GRADING AND DRAINAGE PLAN

Job No. 7934-02 Office Draft M.E.C. F.B. Date 3/17/86	ESPEY, HUSTON & ASSOC., INC. Engineering & Environmental Consultants 4600 INDIAN SCHOOL ROAD N.E. SUITE 320A ALBUQUERQUE, NEW MEXICO 87110 PHONE (505) 256-1555

job title GARDENSWARTS SPORTS 2720 SAN MATEO		
PROJECT MANAGER CHARLES RICK GREEN	job no 8540	date 3/21/86
sheet title GRADING & DRAINAGE PLAN		by M.E.C.

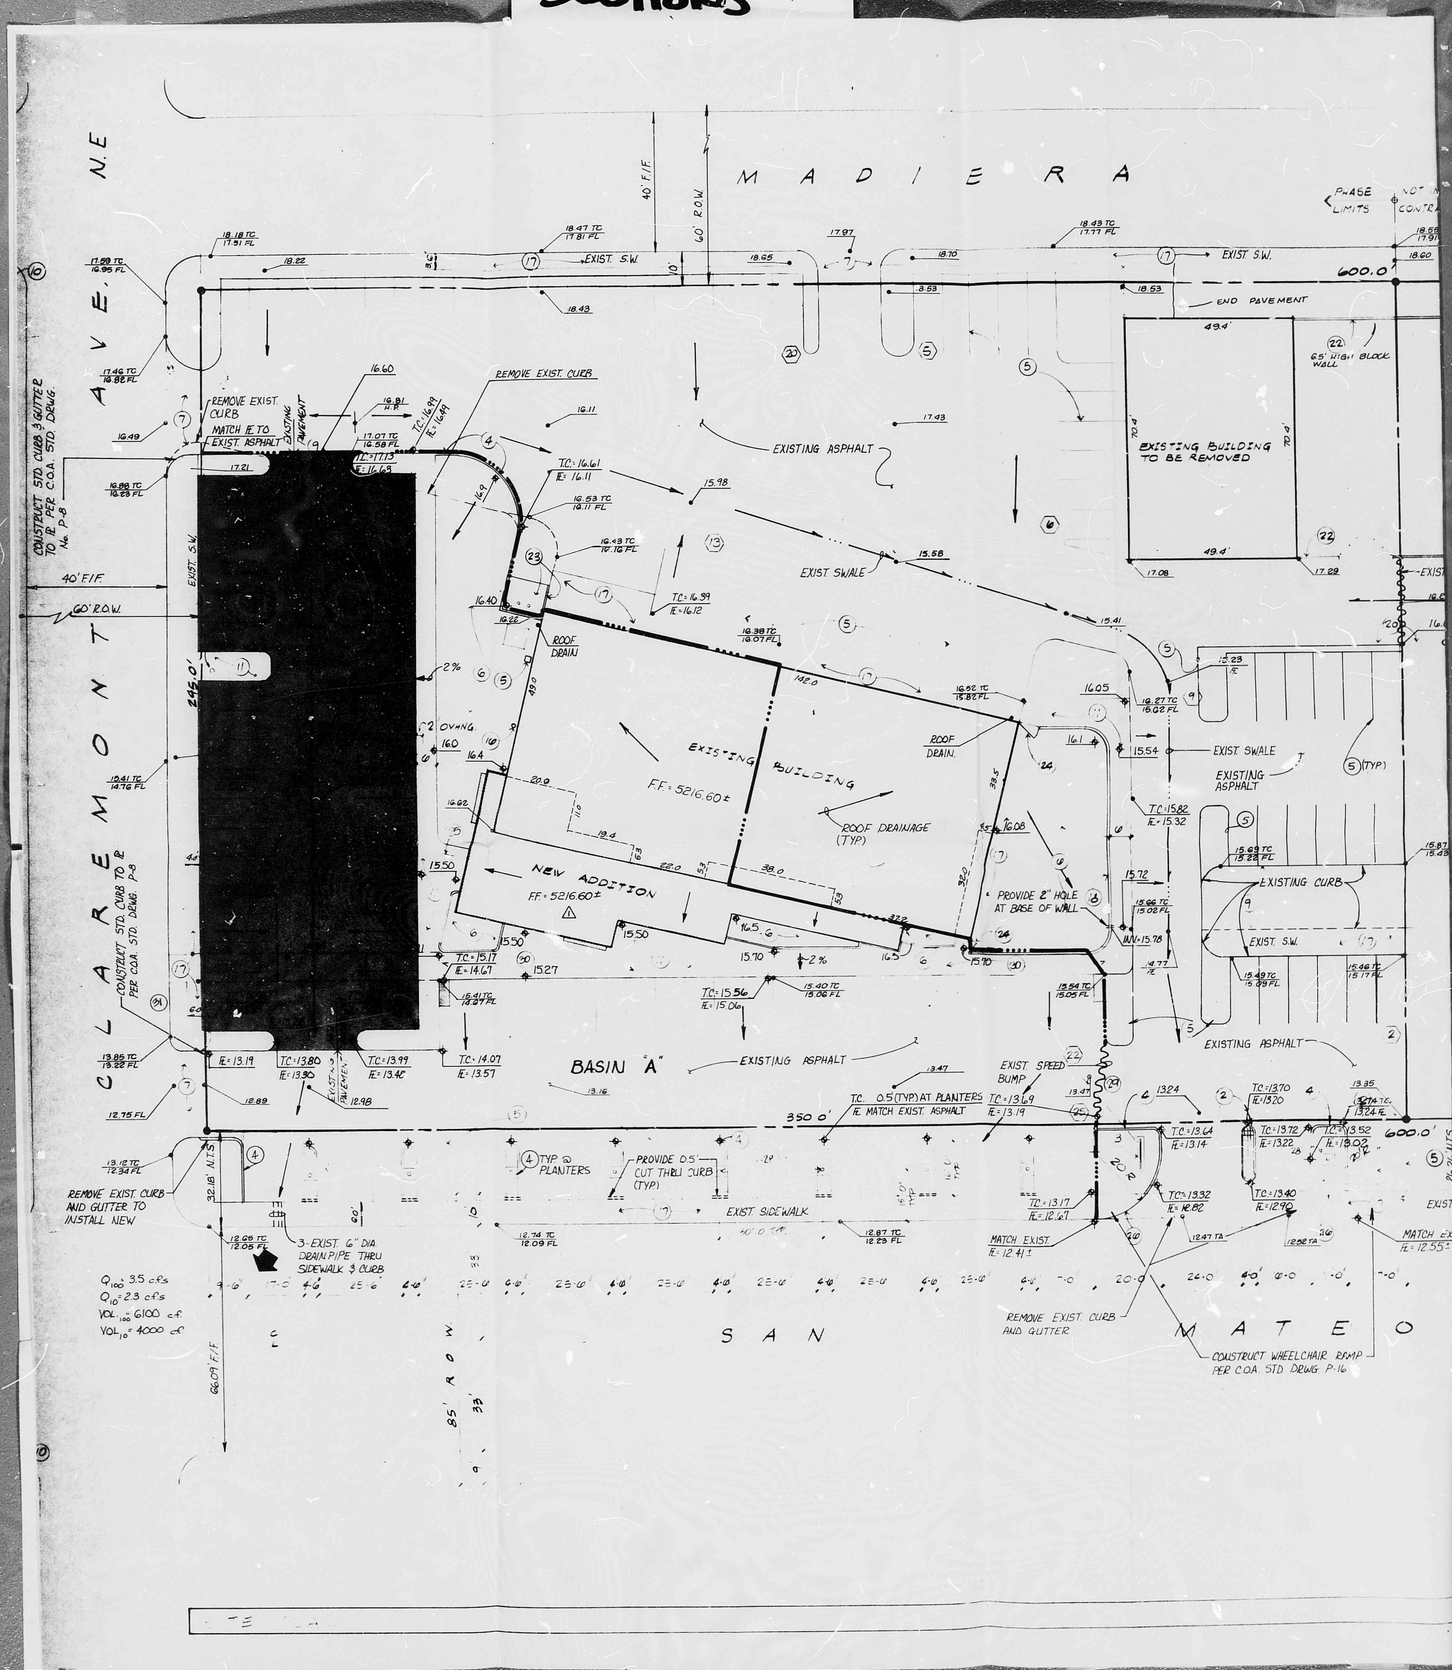
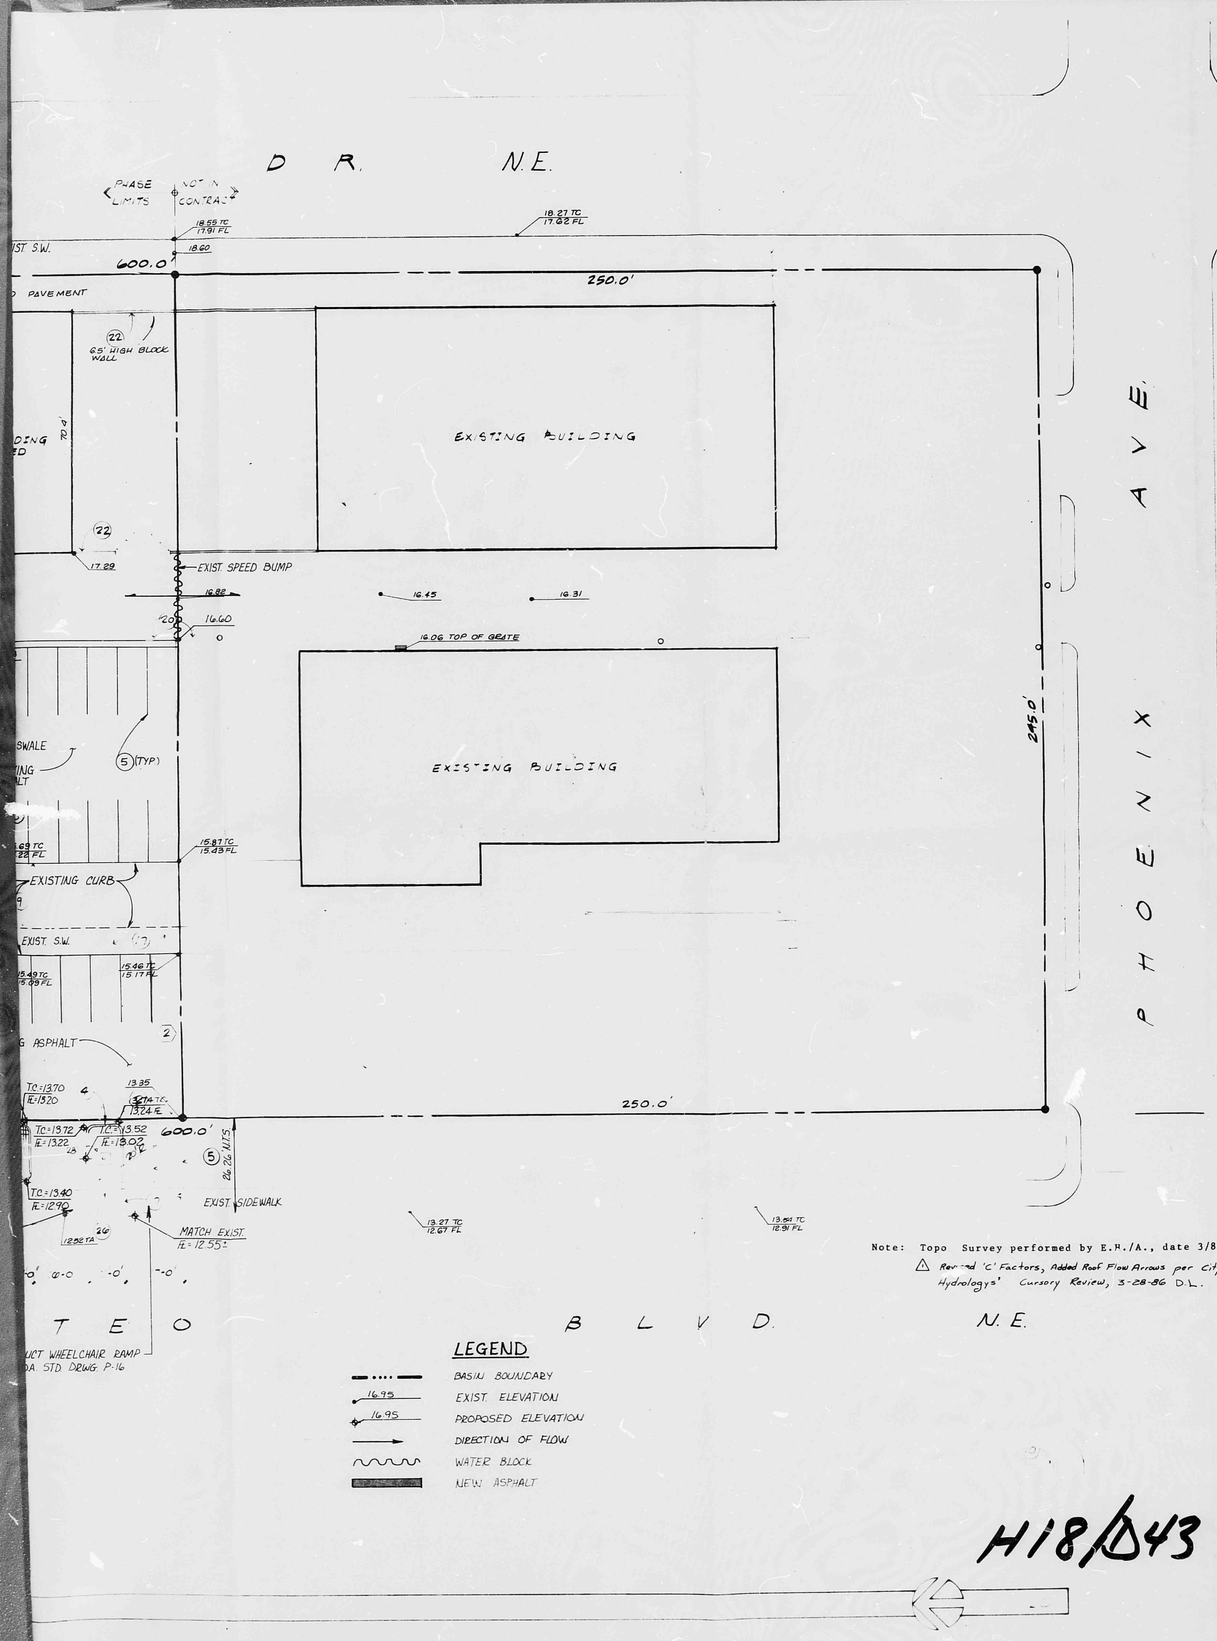
△ Revised 'C' Factors, Added Roof Flow Arrows per City Hydrology's Cursory Review, 3-28-86 D.L.

Basin "A" = 1.0 acre
"CC" = 0.90 $i_{100} = 4.86$ in/hr $C_{LS} = 0.25$ △
$Q_{100} = 4.4$ cfs $Q_{10} = 2.9$ cfs $C_{STREET} = 0.95$, $C_{ROOF} = 0.90$
$Vol_{100} = 7500$ cf $Vol_{10} = 4900$ cf

△ 0 creates minimal detention of run-off in the 100-yr. event.
